Documents for Continuance of the 4/20/22 Hearing on May 11

Certificate of Appropriateness

Project Address: 708 Main Street

Revision and Comparison

1 Existing/Demo First Floor Plan
Scale: 1/8" = 1'-0"

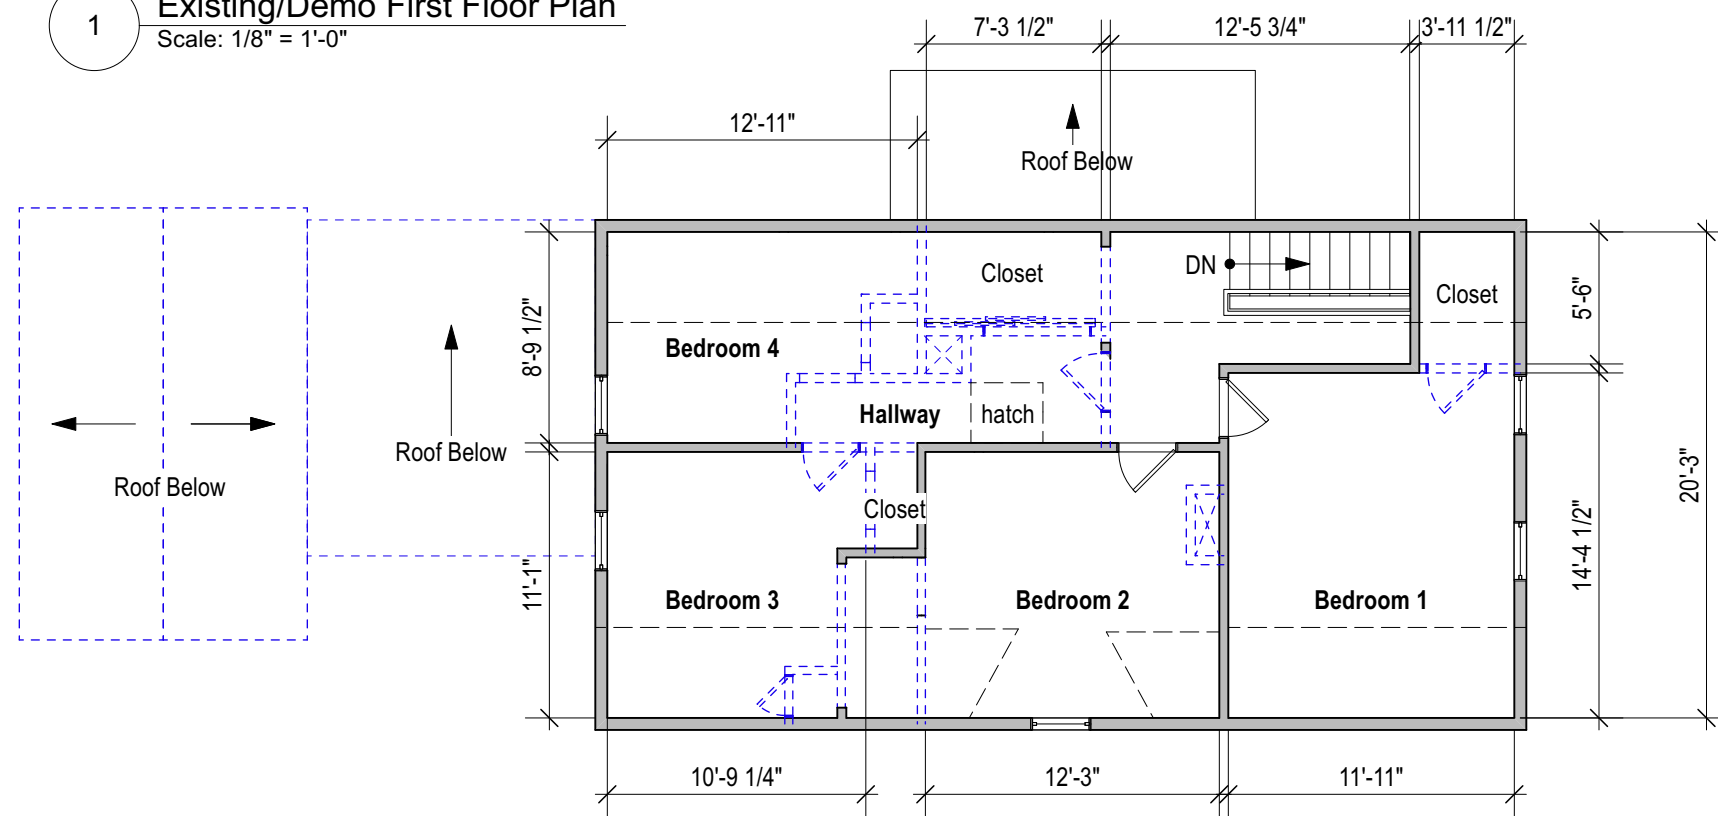
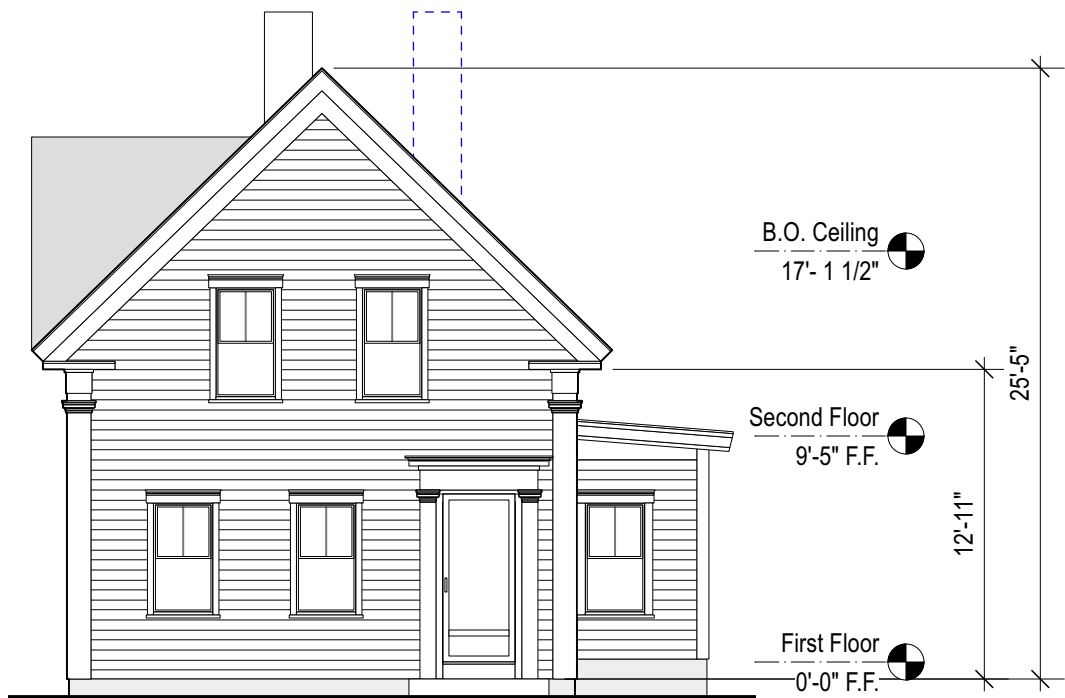
1. All Existing Windows are replaced in place
2. Windows shown in dashed blue are removed and changed

SIDE DOOR

FRONT DOOR

1 Existing South Elevation
Scale: 1/8" = 1'-0"

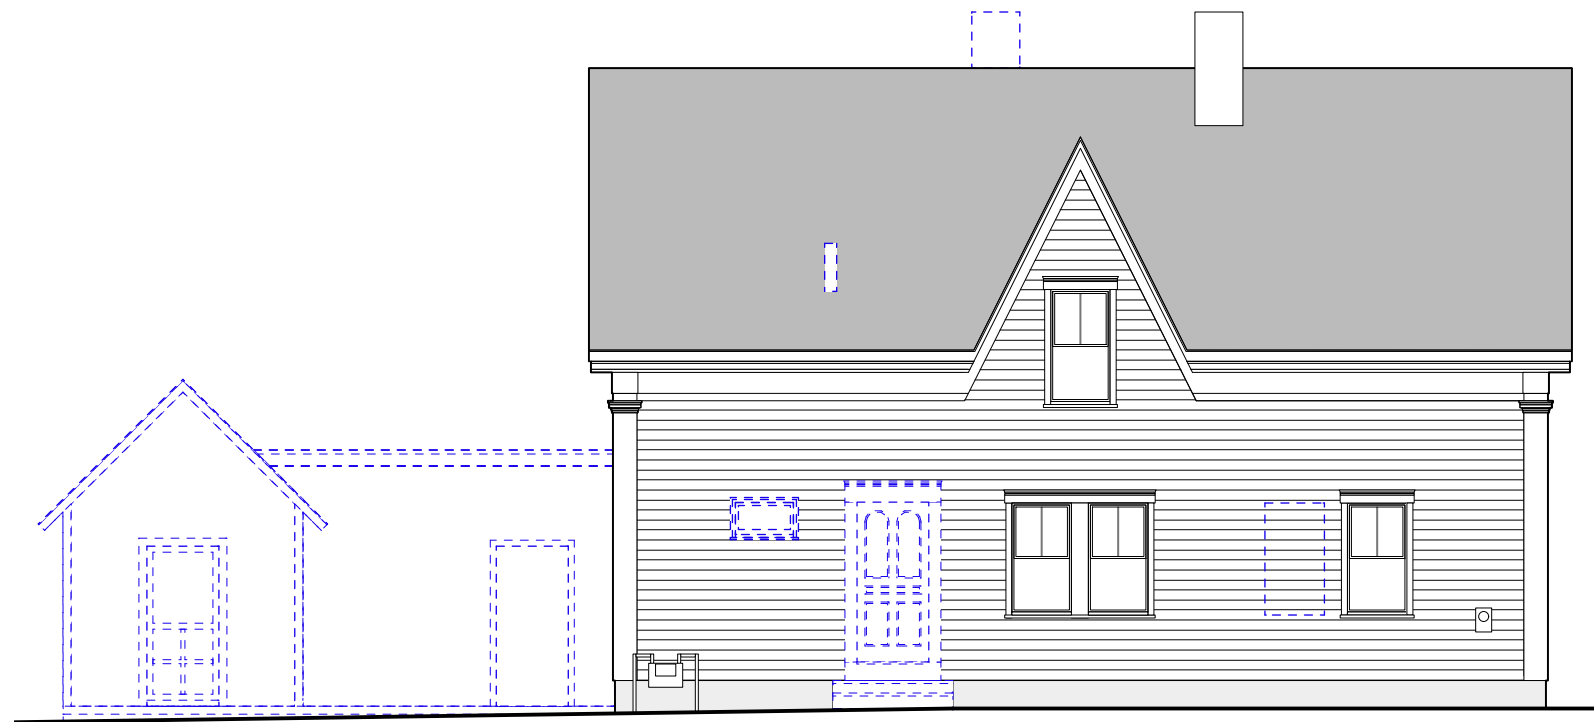
Note:
1. Remove flower box holders

1 Site Plan
Scale: 1/16" = 1'-0"

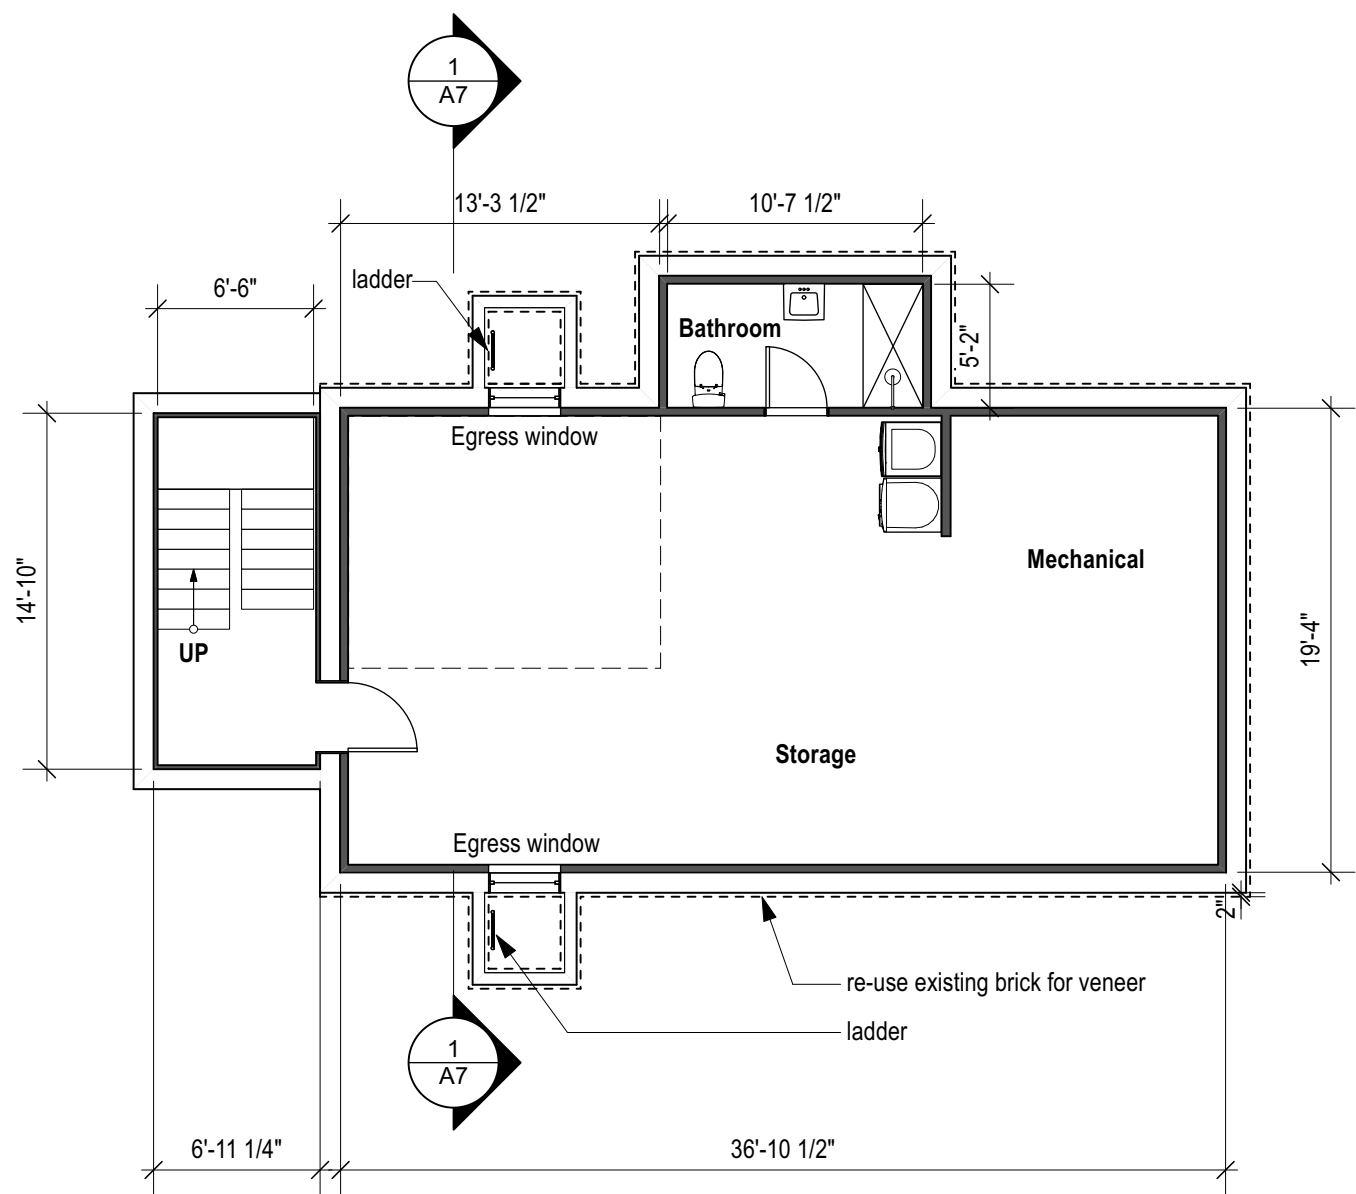
Note:
Dimensions need to be adjusted

2 Proposed First Floor Plan
Scale: 1/8" = 1'-0"

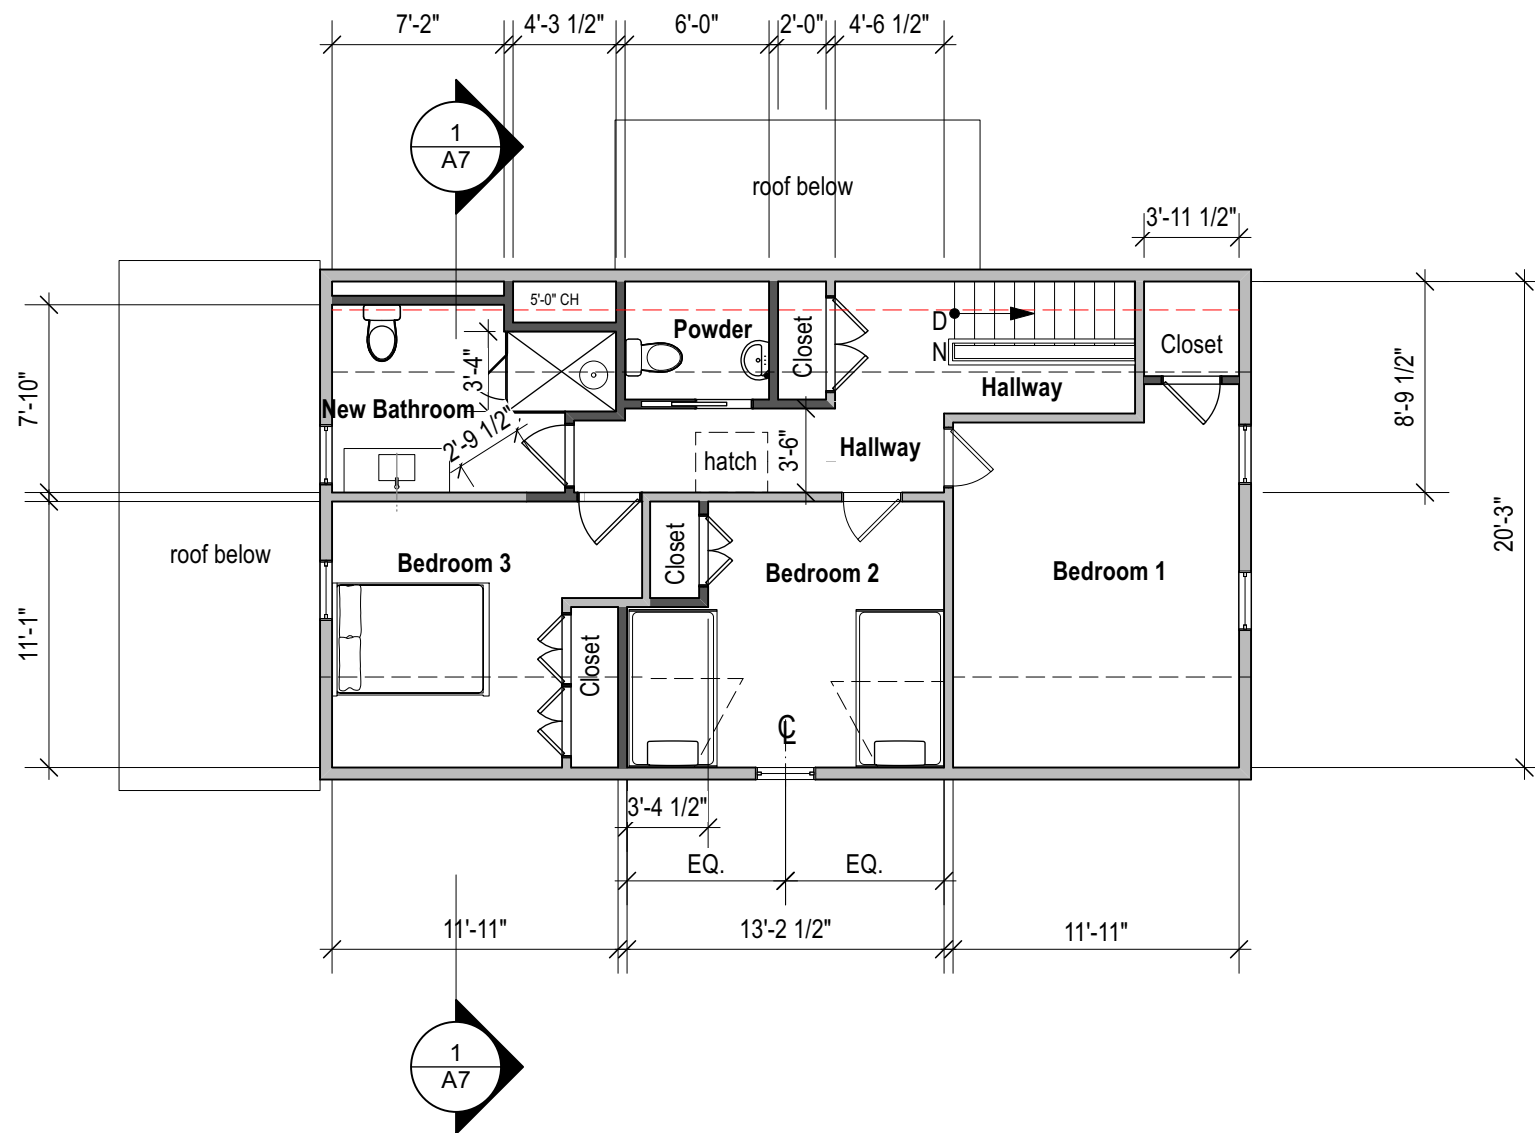
* Use restored side door as front door

1 **Proposed South Elevation**
Scale: 1/8" = 1'-0"

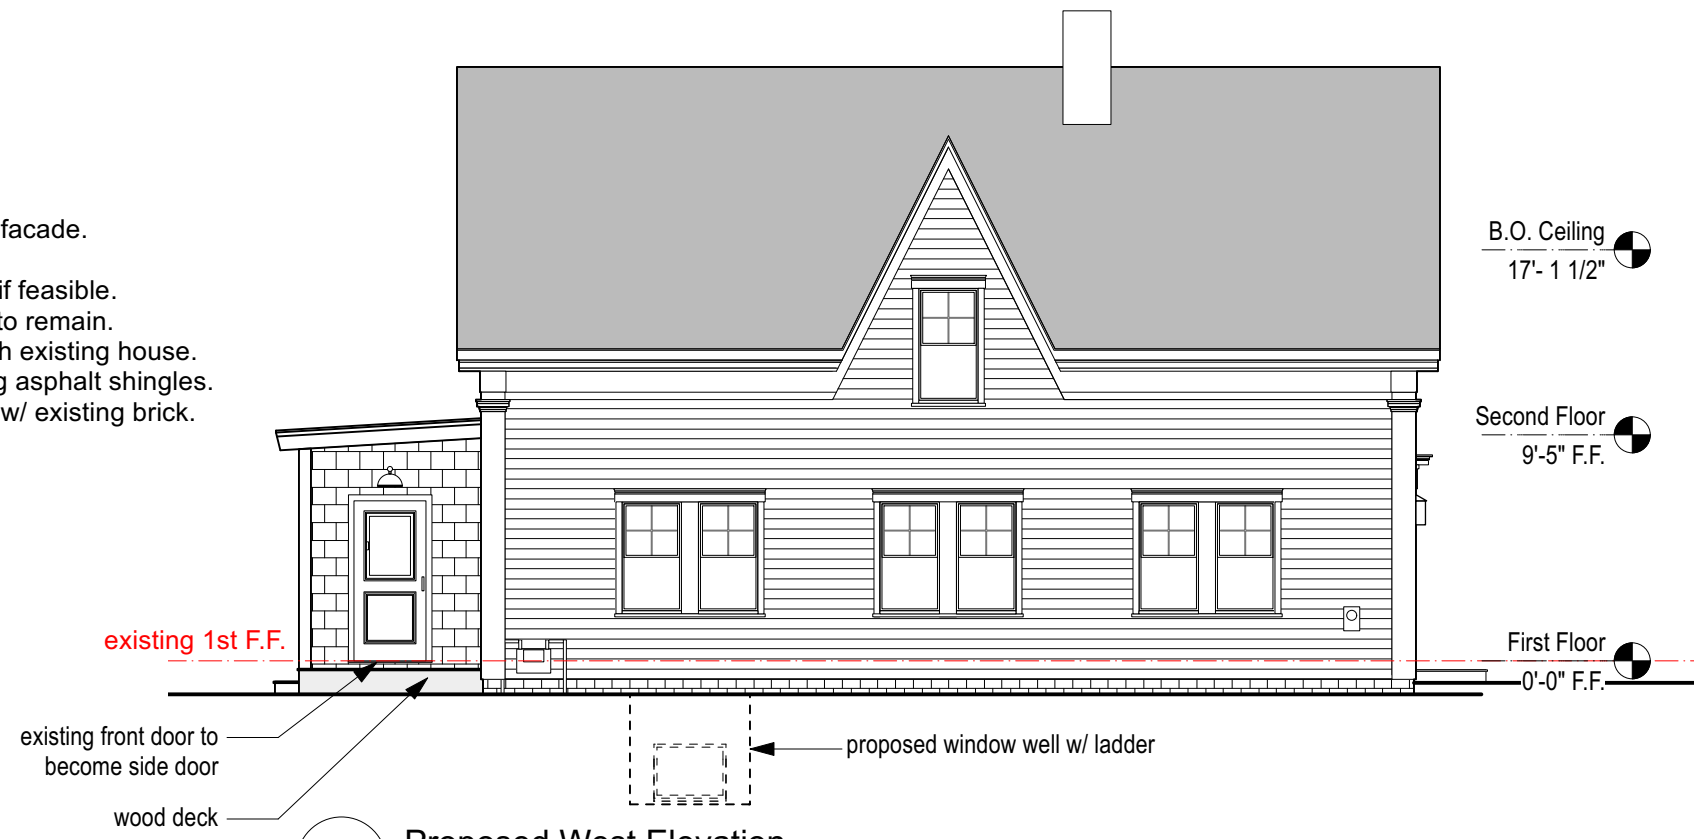
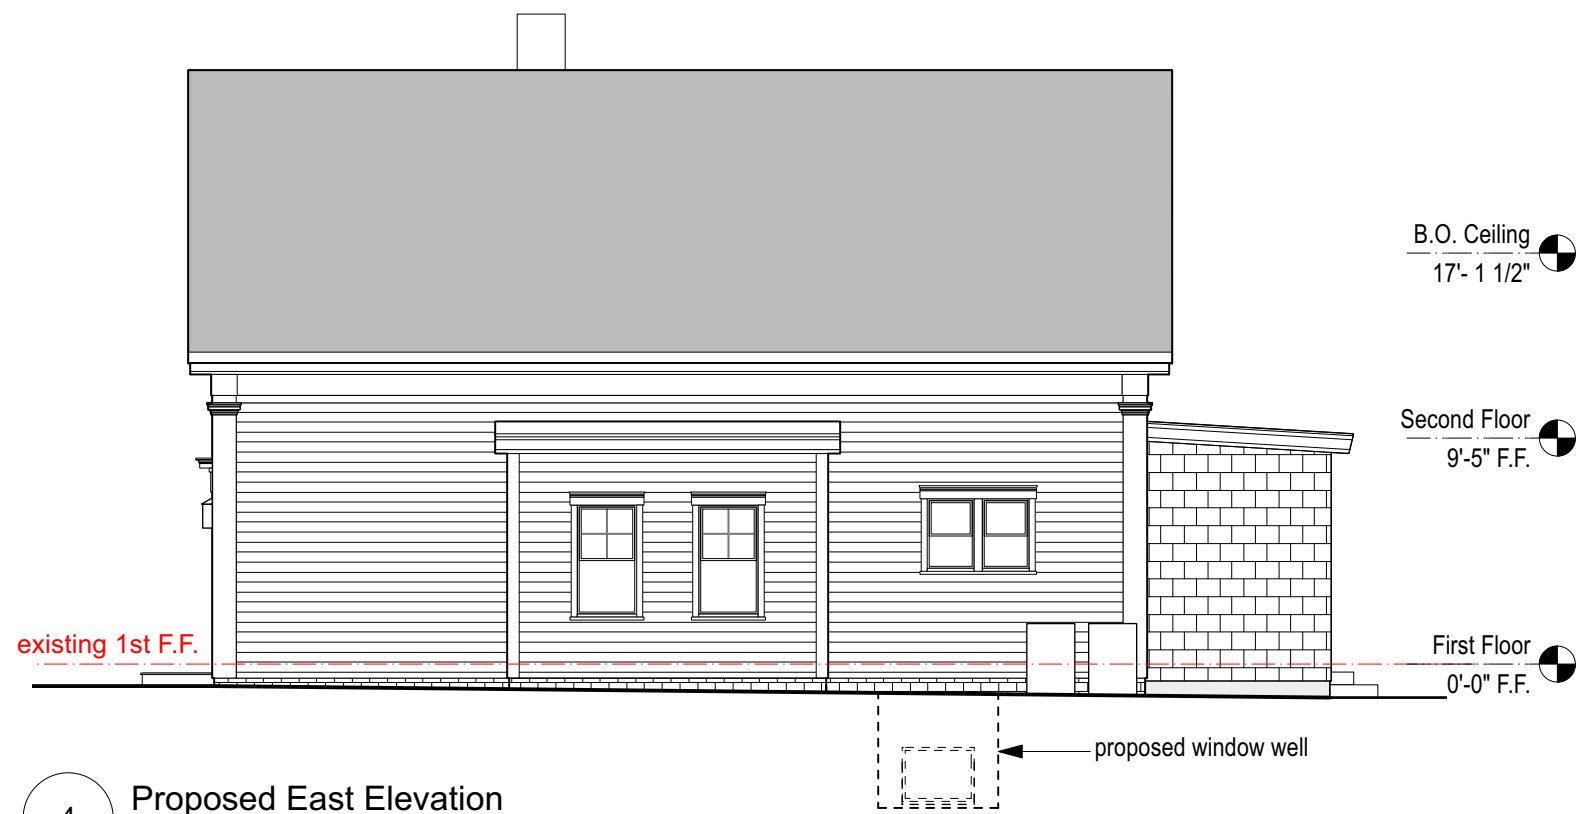
- Note:**
1. Add exist., salvaged shutters to front facade.
 2. Replace all windows
 3. Re-use existing front and side doors if feasible.
 4. Wood siding, trim, pilasters and roof to remain.
 5. Paint the back addition white to match existing house.
 6. Patch Roof shingles to match existing asphalt shingles.
 7. Veneer over the concrete foundation w/ existing brick.
